THE CITY OF SAN DIEGO

ADDENDUM TO A ENVIRONMENTAL IMPACT REPORT

Project No. 516820
Addendum to EIR No. 233958
SCH No.: 2011031074

SUBJECT: **BALBOA PARK PLAZA DE PANAMA PROJECT:** The following approvals are being requested in association with the project: AUTHORIZE A COOPERATION AGREEMENT BETWEEN THE CITY AND THE PLAZA DE PANAMA COMMITTEE, AUTHORIZE THE MAYOR TO AWARD A CONSTRUCTION CONTRACT FOR THE PROJECT, and AUTHORIZE FUNDING for Project. The Plaza de Panama Project, as previously approved proposes to remove vehicular access and parking from the Plaza de Panama, El Prado, Plaza de California, the Mall, and Pan American Road East and allow these areas to be used by pedestrians only. A new bridge, "Centennial Bridge," would connect the eastern end of Cabrillo Bridge to the western side of the Alcazar parking lot. From that point a new "Centennial Road" would traverse through the Alcazar parking lot exiting to the east, continue to the south past a new Organ Pavilion parking structure and then connect to Presidents Way. Additional parkland would be provided atop the new parking structure. A tram would provide service from the parking structure to the Plaza de Panama with possi

FIGURE 1
Refinements to Centennial Bridge

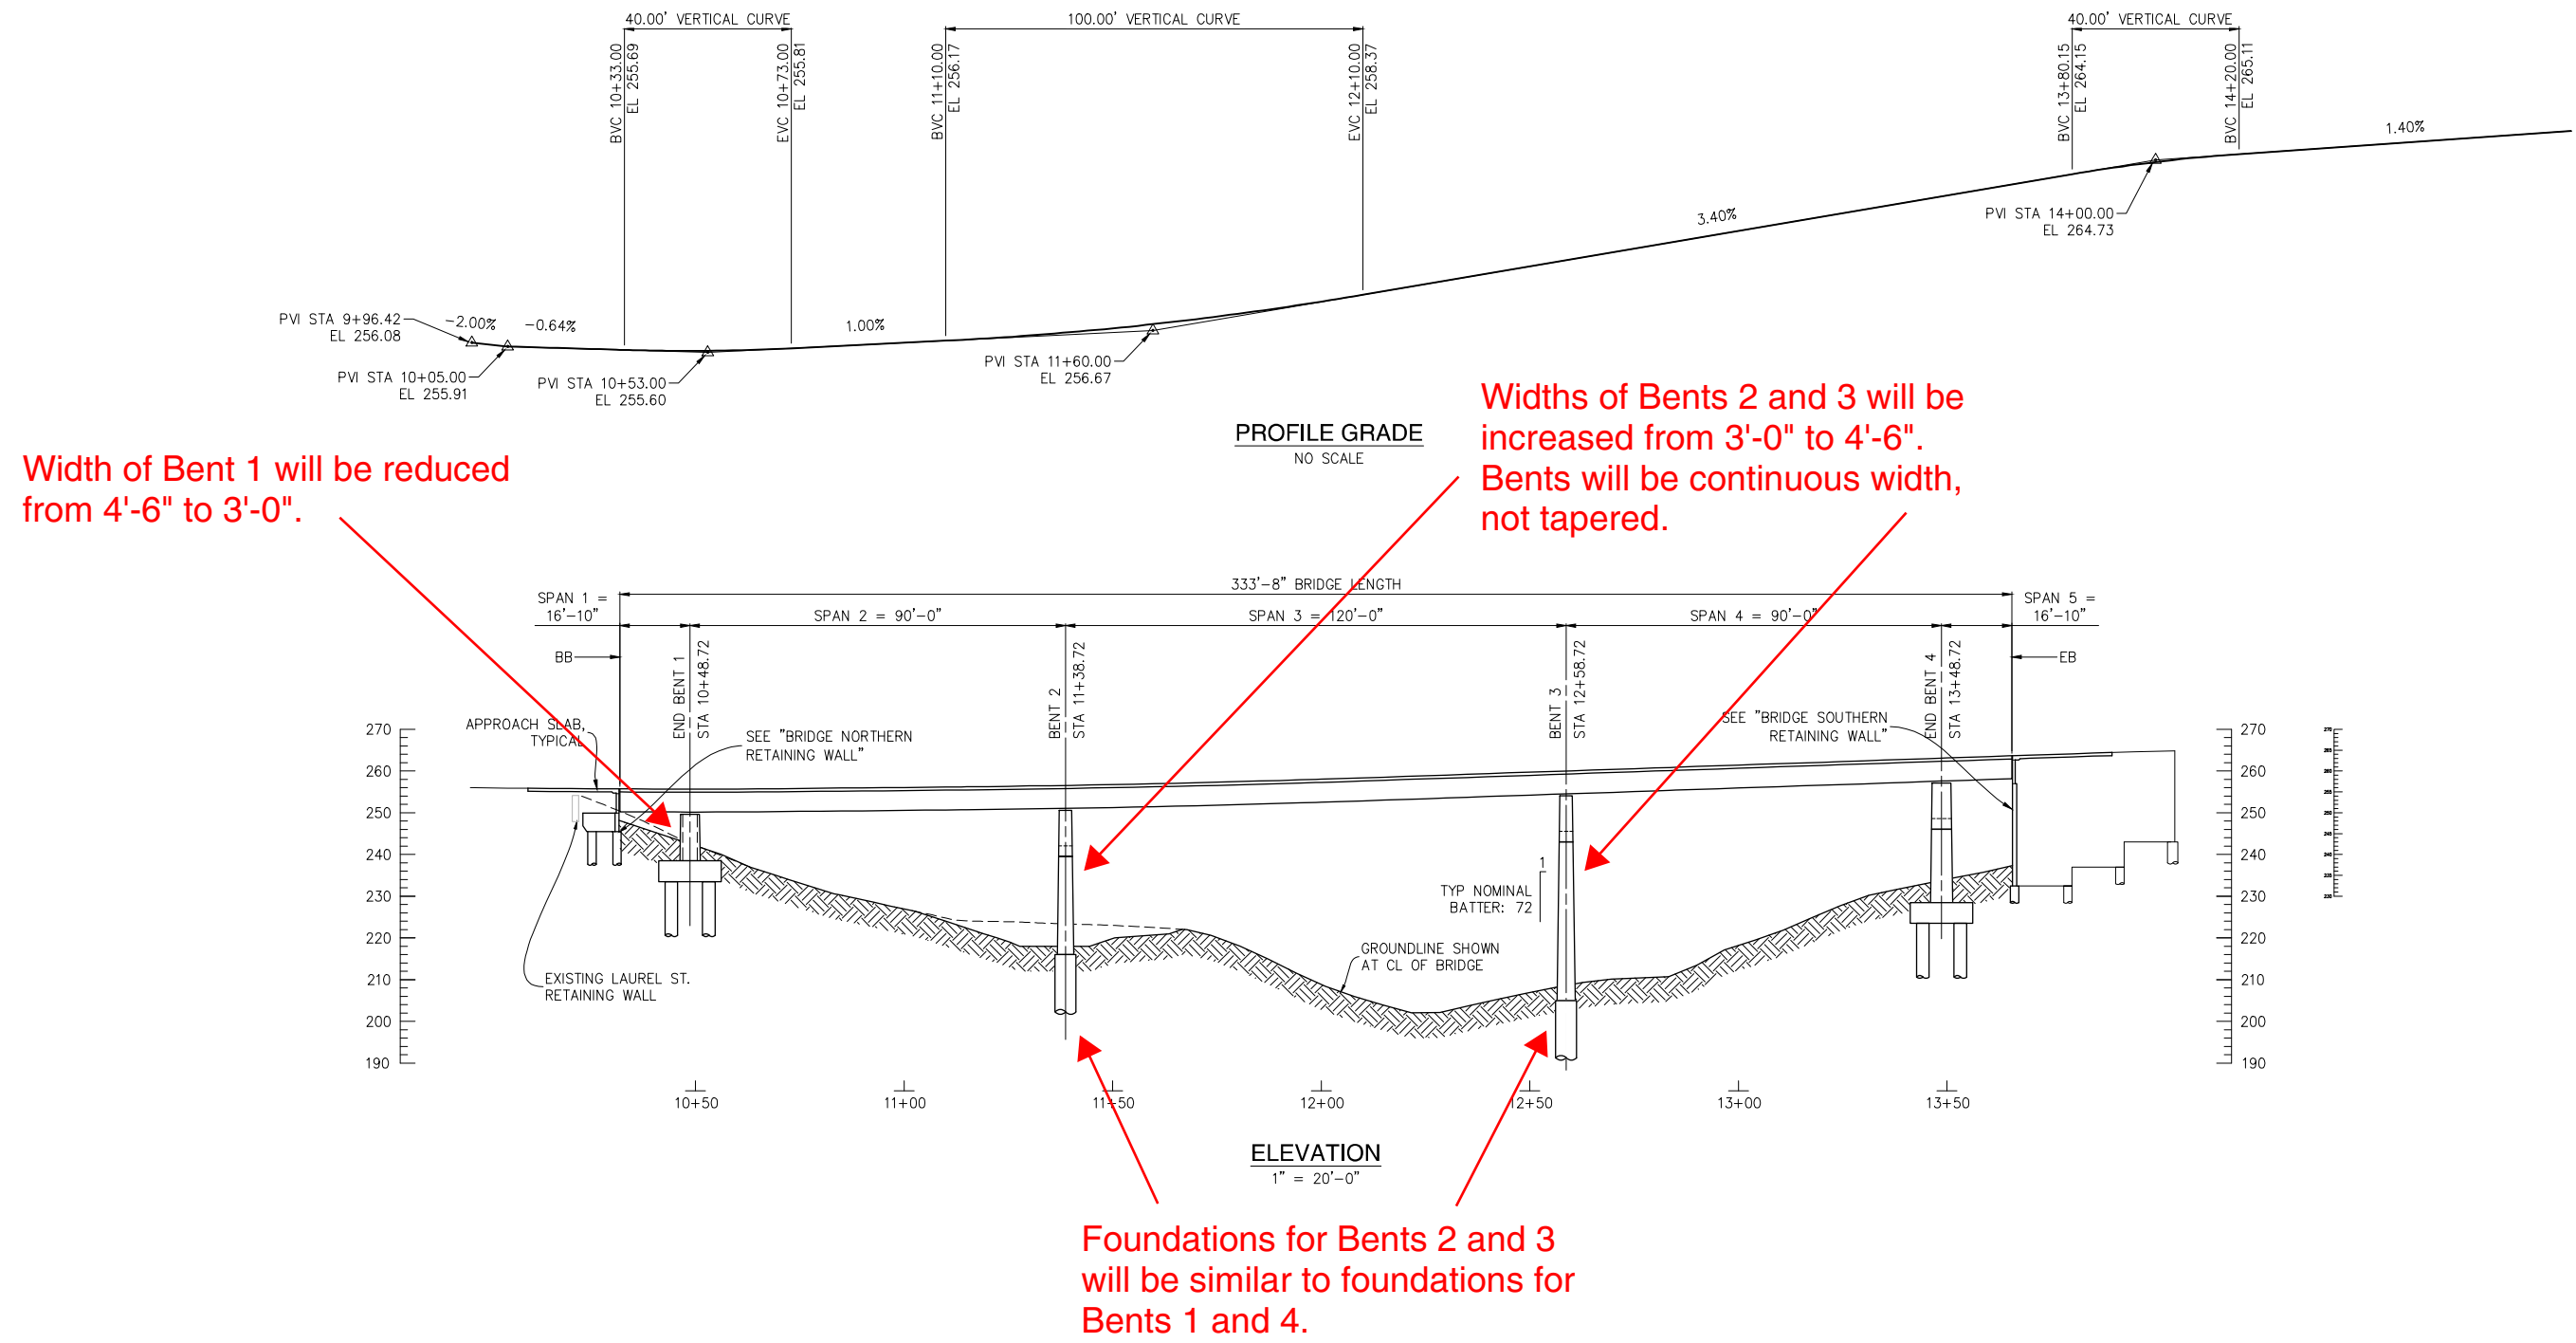
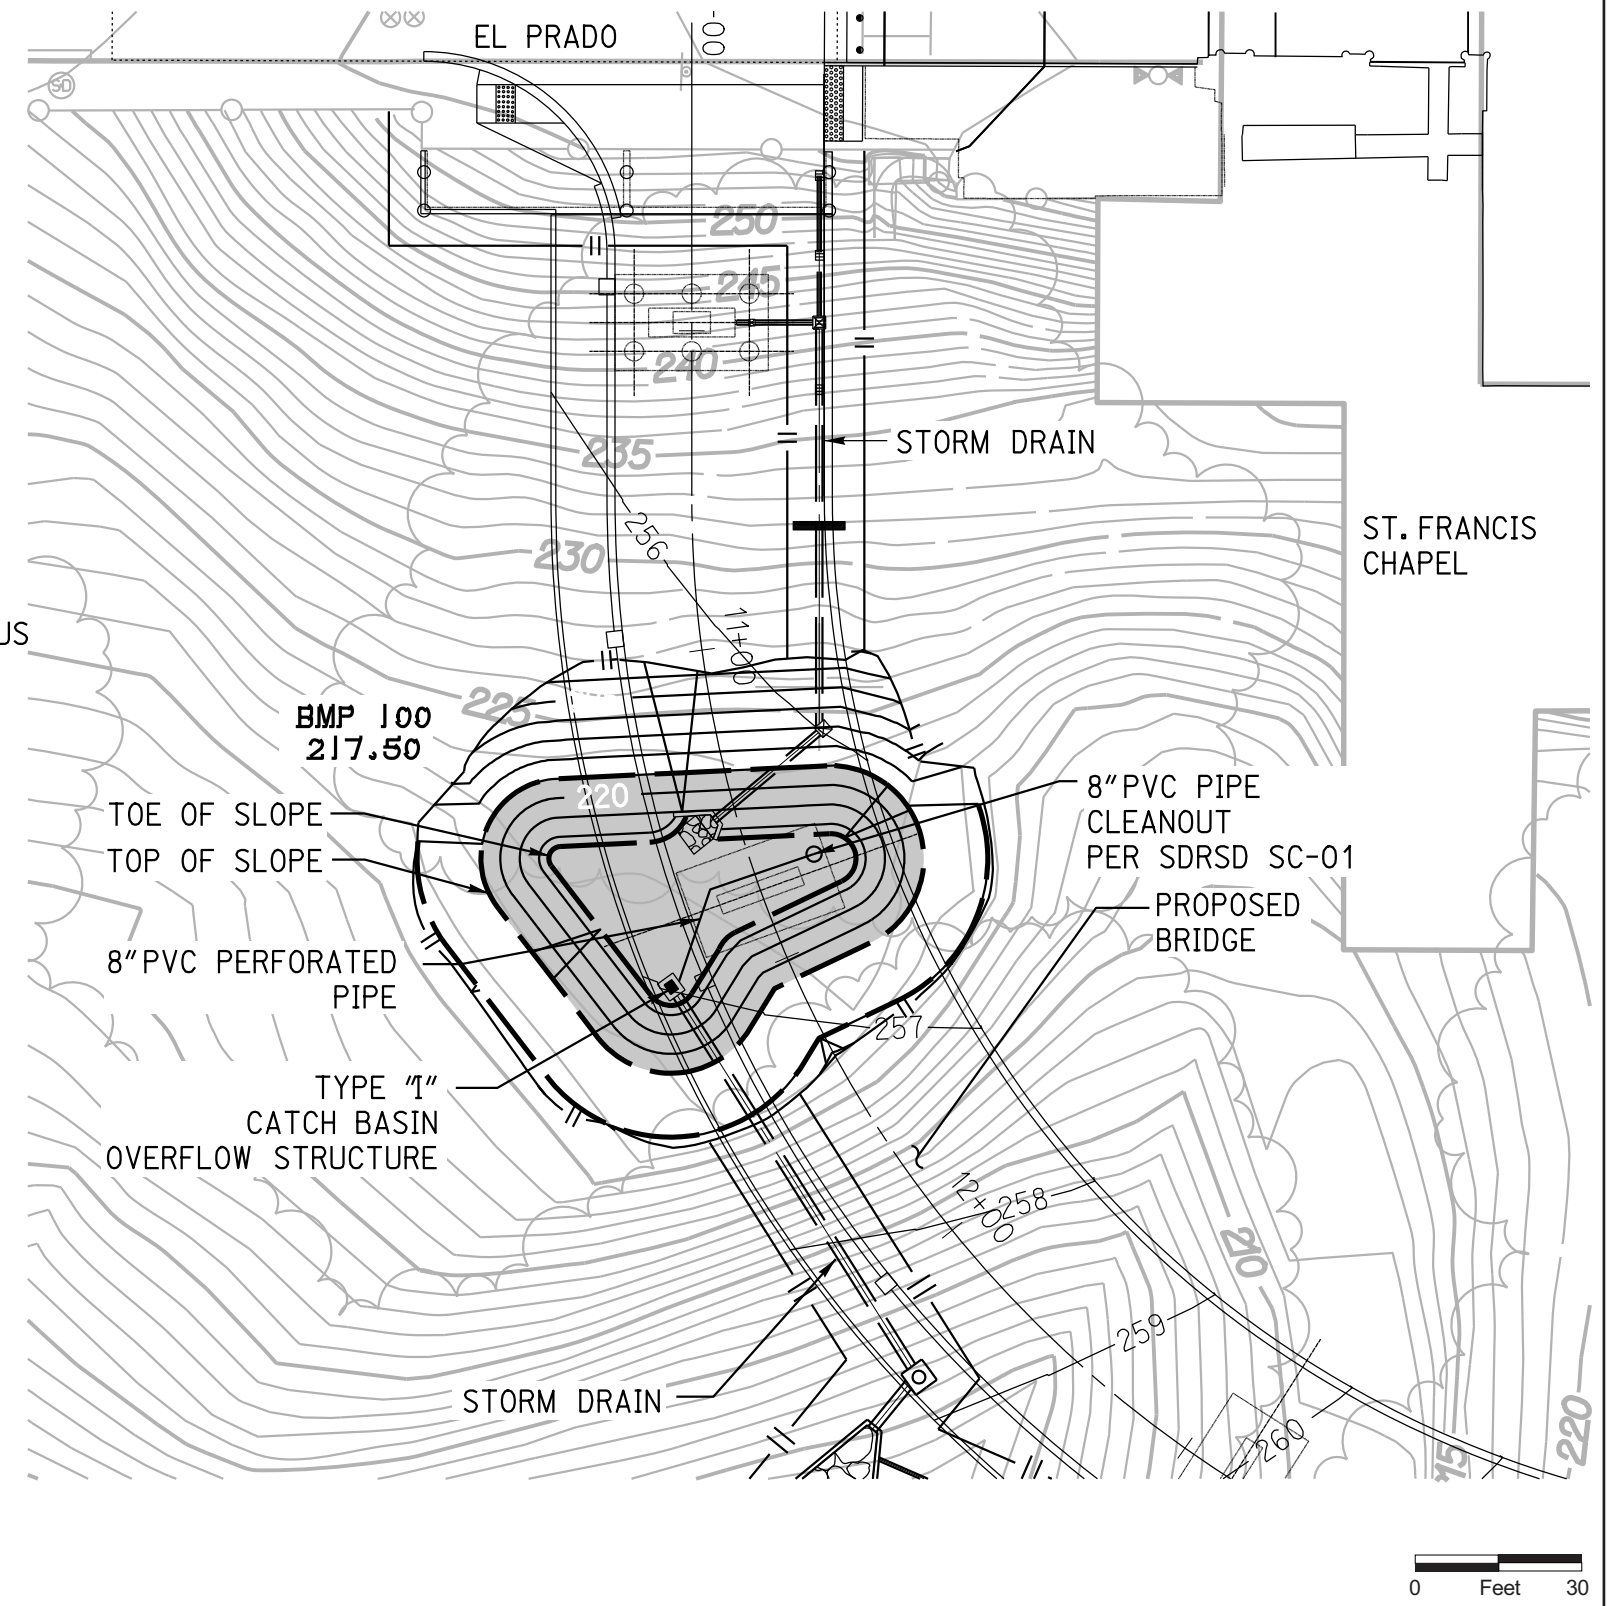
- **Centennial Bridge Supports** – Minor changes to the bents (columns) of the proposed Centennial Bridge are required to meet new California Department of Transportation (Caltrans) requirements. The number of bents has been reduced from six to four (Figure 1).

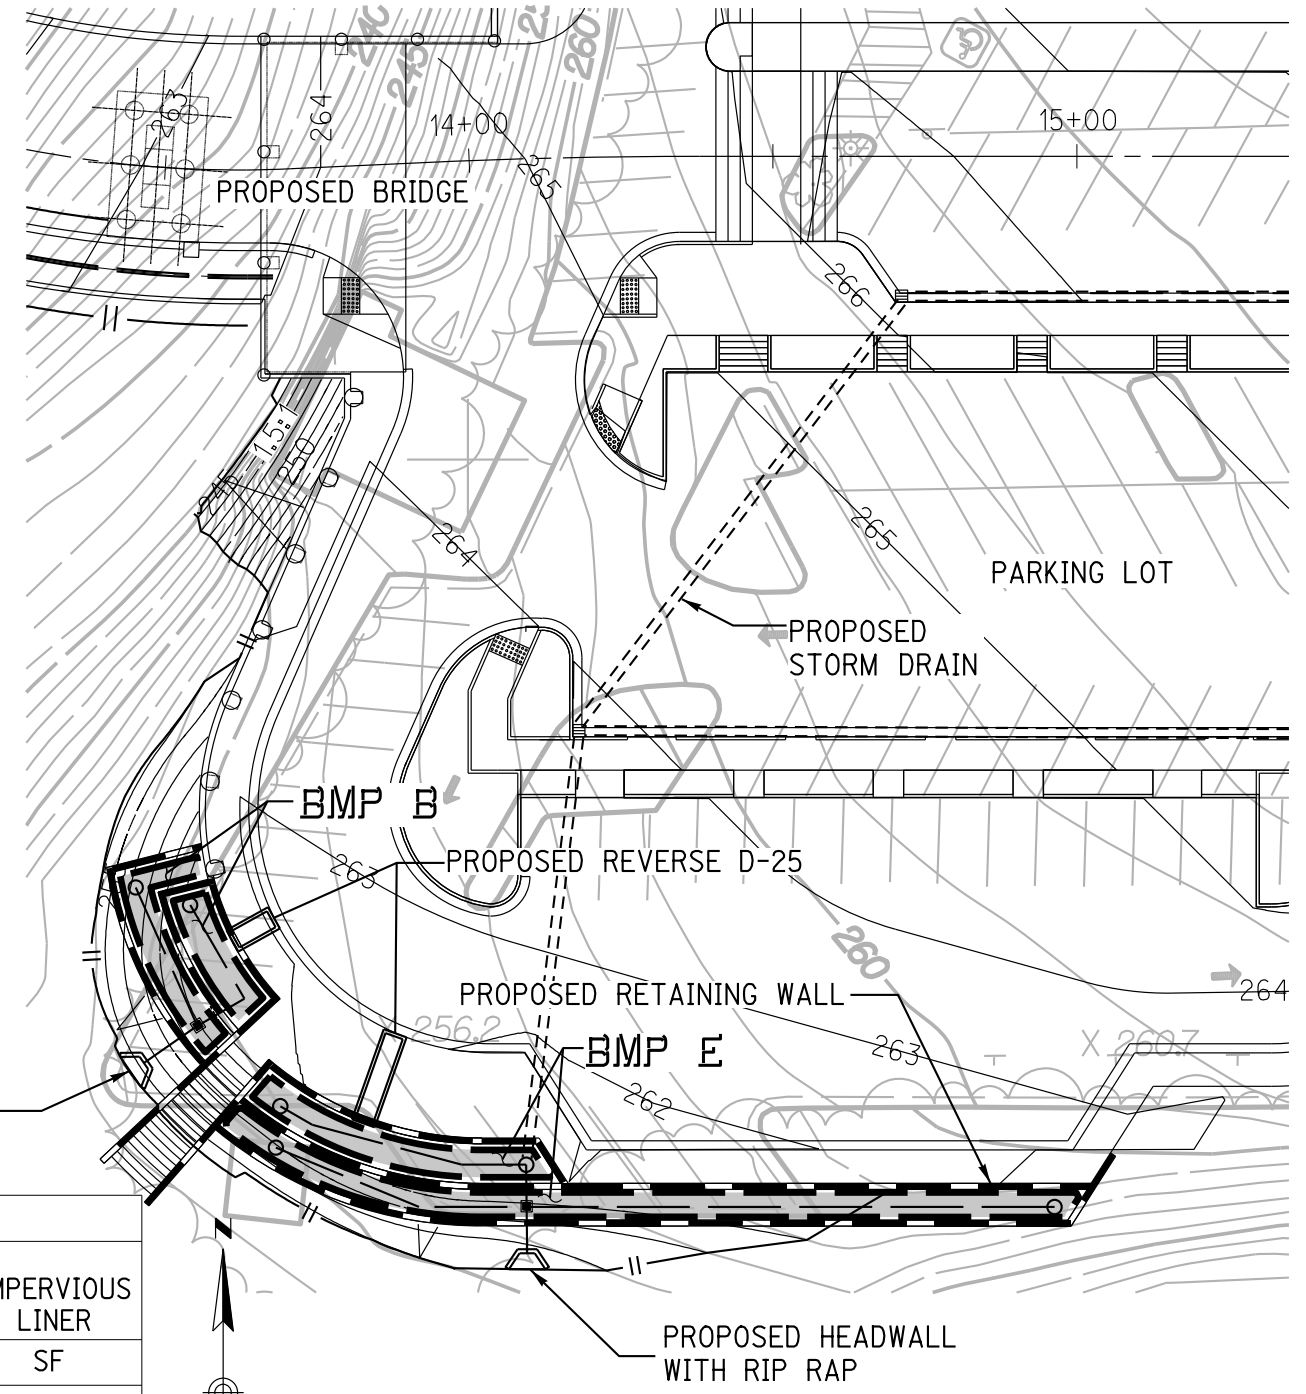
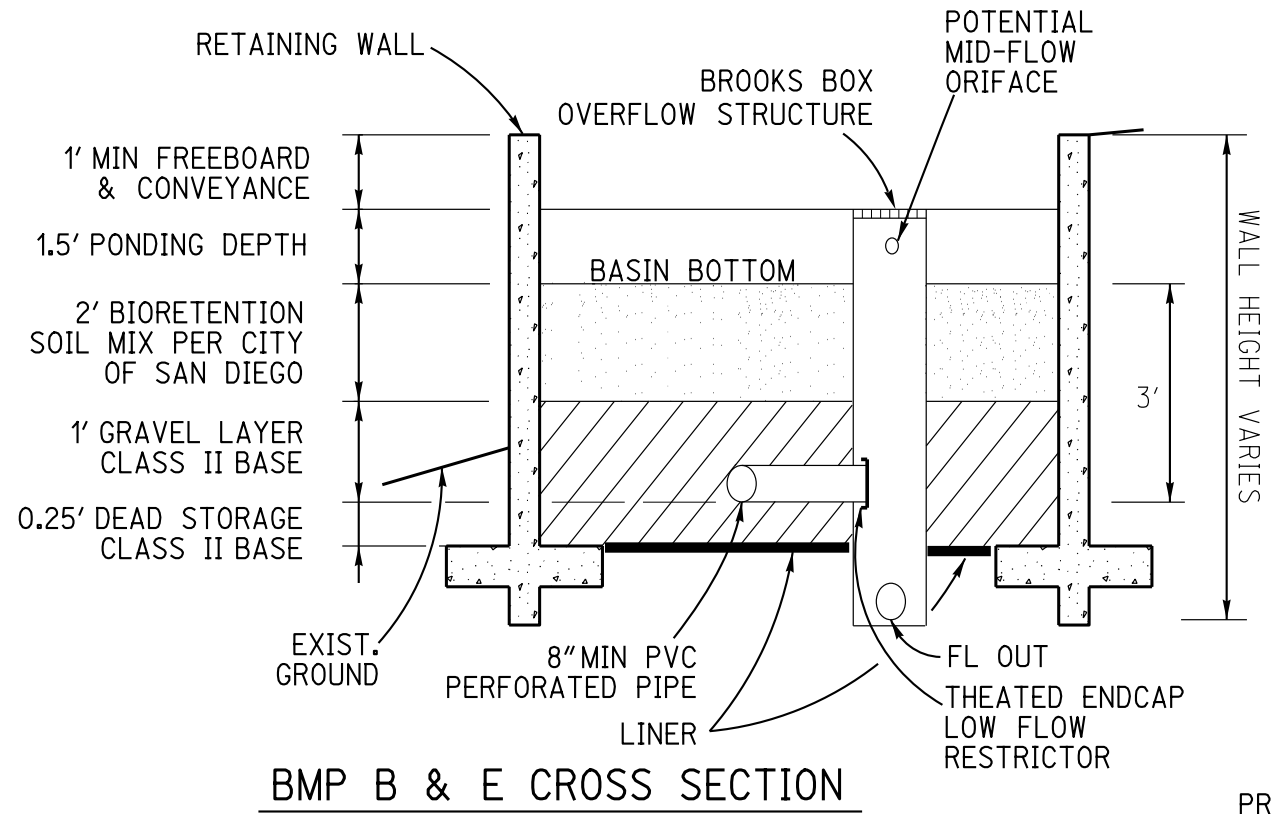
- **BMP A** – This basin, located underneath Centennial Bridge was included in the 2012 project. This basin would have a slightly smaller footprint as compared to what was shown in the original project (Figure 2).
